PRESS RELEASE

New and Improved ICC Voice/Data Modular Connectors

La Mirada, CA— October 23, 2009

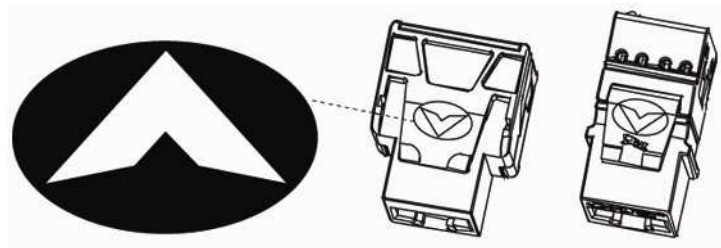
In an effort to improve performance and streamline termination of voice and data modular connectors, ICC has made some changes to the wiring scheme along with changes to the housing. CAT 5e, CAT 6 and CAT 6a modular connectors now all have the same pair-to-pair wiring scheme for improved performance. In addition, the IDC height has been increased for easy wire placement and improved cable retention. Since both voice and data modular connectors now have the same housing, a brand new 4-pair combo termination tool will be made available soon for terminating both EZ/HD voice and data connectors. No more carrying around different tools for each kind of connector. (Single blade punch-down tool* can still be used for termination.)
